Reply to Comments on Stability Risk Assessment

Withyhedge Landfill Permit Variation

Restoration Sections

The increase of final waste volume (to 320,307m³) will generate more leachate. Can you confirm how critical excessive leachate levels and hence additional loading will be considered as the overtip areas have been shown to only just be within the loading limits of acceptability.

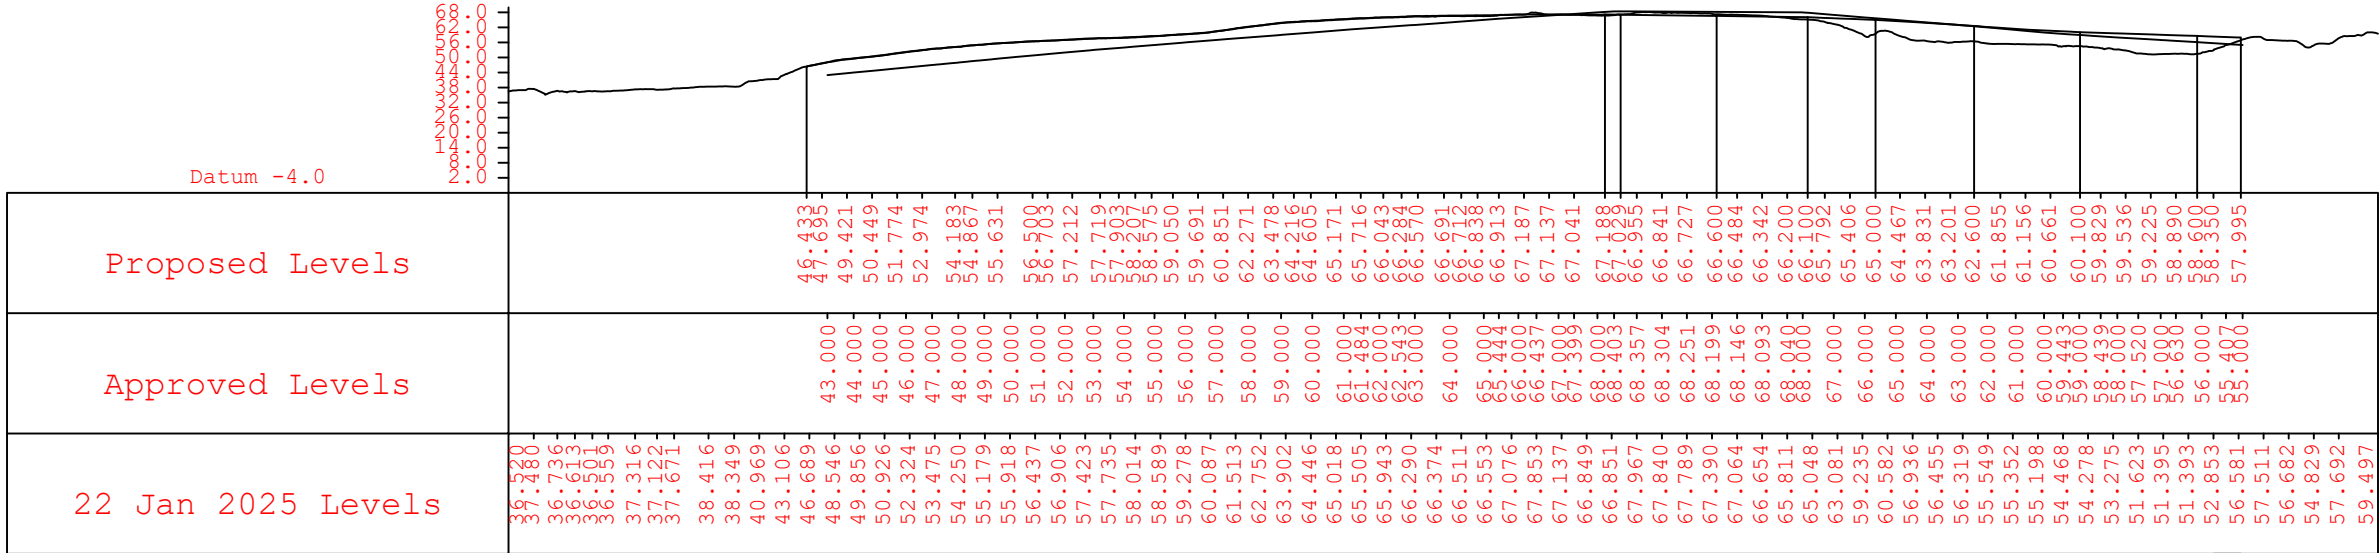
Only one cross section has been provided to illustrate the revised profiling. Please can you provide more cross sections from across the site, comparing the approved and proposed waste thickness and slope angles.

A series of cross sections have been produced as Drawing 2365/17 which is submitted along with this response. NRW is reminded that it has access to the full 3d modelling and topographic survey system shared with it by RML. In the event that any of the review team would like instruction on the use of the system Geotechnology will be happy to assist.
